Watts Bar Nuclear Plant, Unit 2
NRC Docket No. 50-391

Subject: Watts Bar Nuclear Plant (WBN) Unit 2 – Submittal of Revised Section 4.3, "Fuel Storage," Developmental Revision G of the Unit 2 Technical Specification (TS)

WBN Unit 2 TS Section 4.3 Mark-up

FIGURE 4.3-3

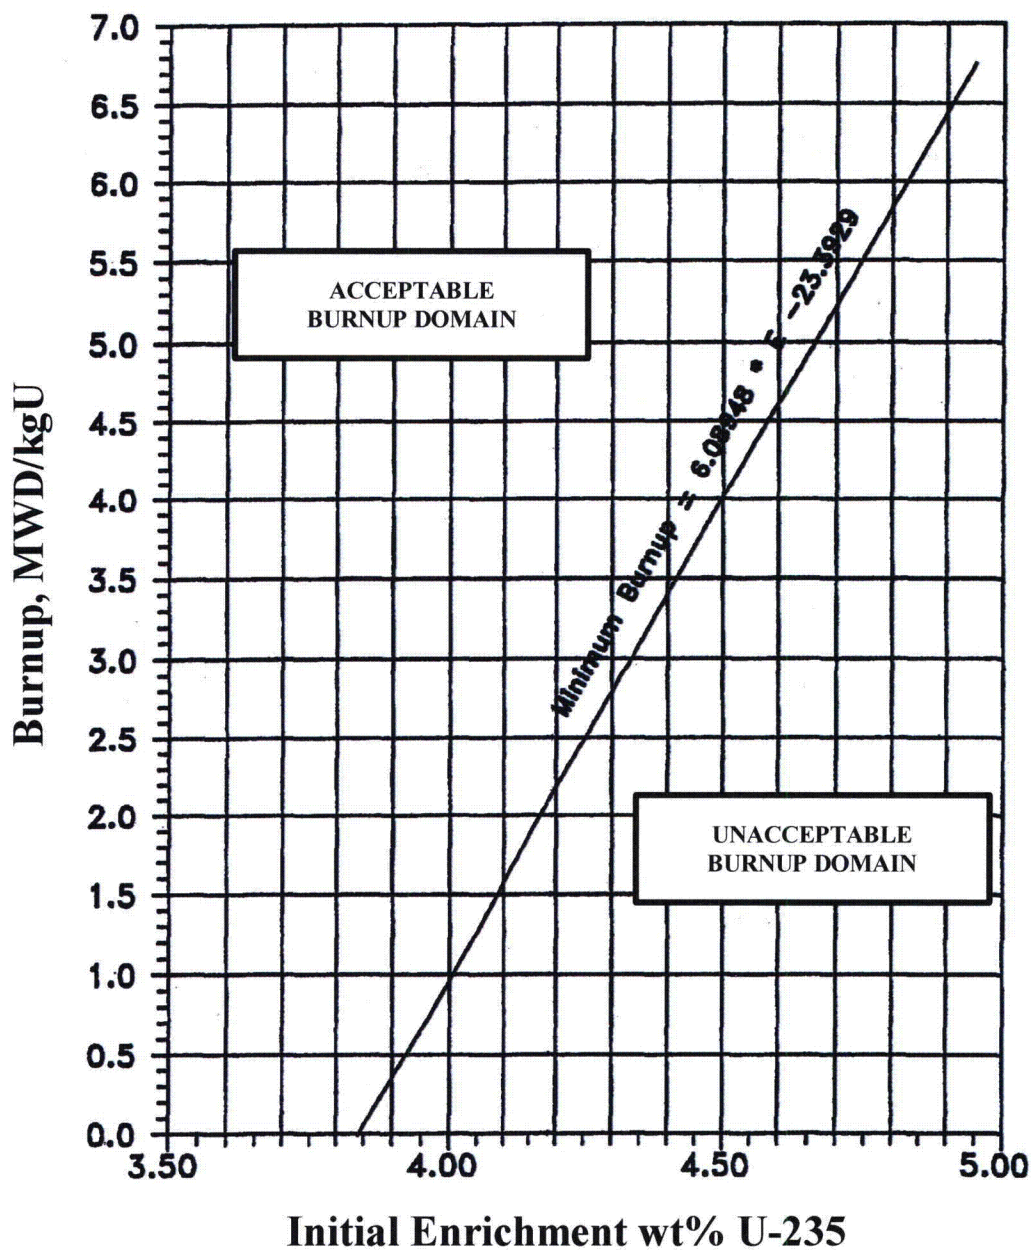
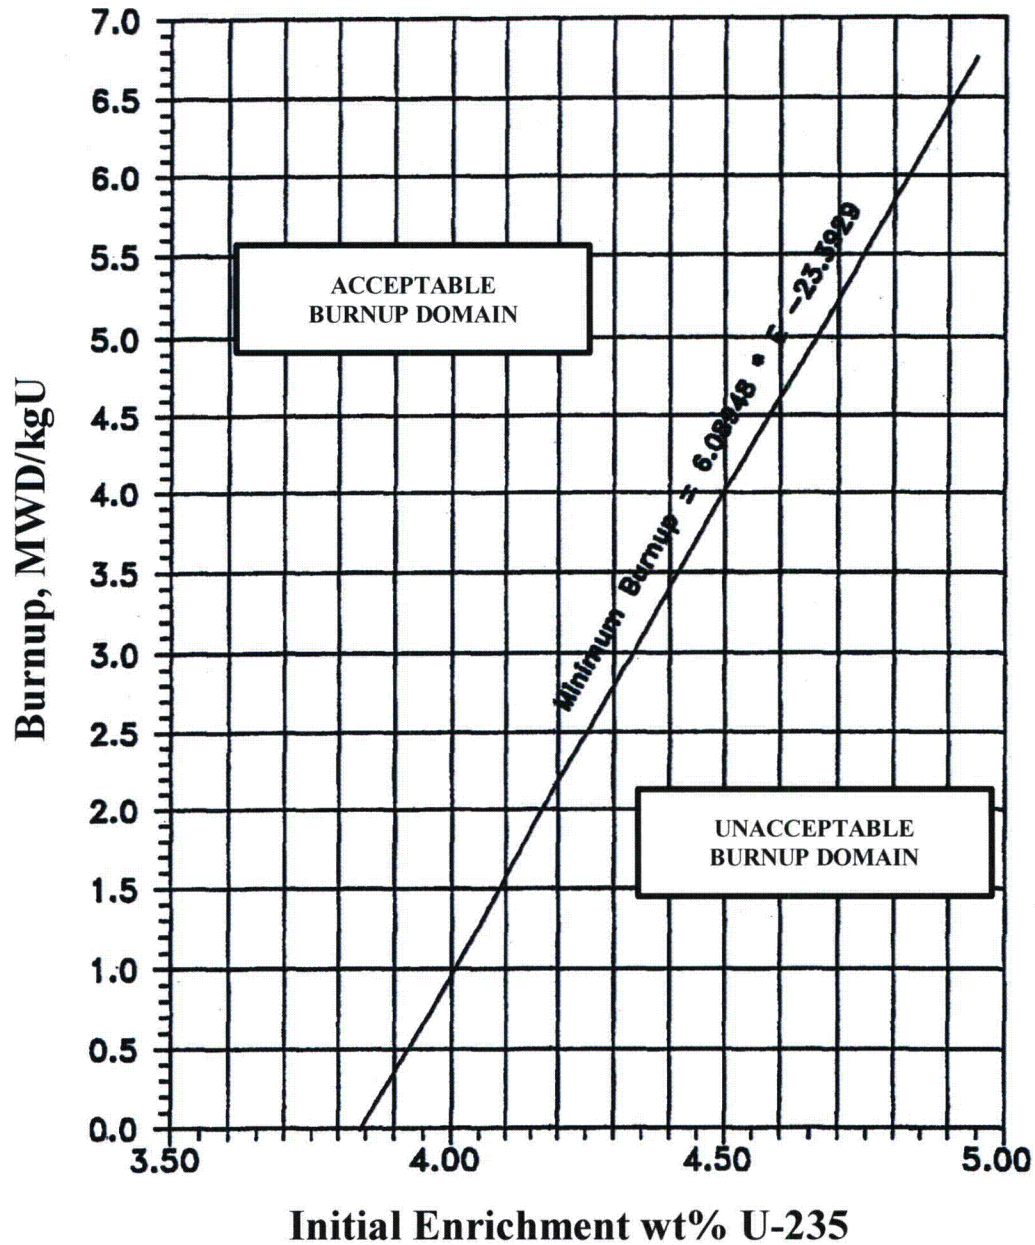
This letter provides a correction to TS Section 4.3 on Fuel Storage previously submitted by the referenced letter. Also provided is a change to the title of Figure 4.3.3. This change was not made previously and is being made to clarify that the figure also applies to new fuel stored in fuel pool.

MINIMUM REQUIRED BURNUP FOR UNRESTRICTED STORAGE
OF **NEW AND** SPENT FUEL OF VARIOUS INITIAL ENRICHMENTS

MINIMUM REQUIRED BURNUP FOR UNRESTRICTED STORAGE
OF NEW AND SPENT FUEL OF VARIOUS INITIAL ENRICHMENTS
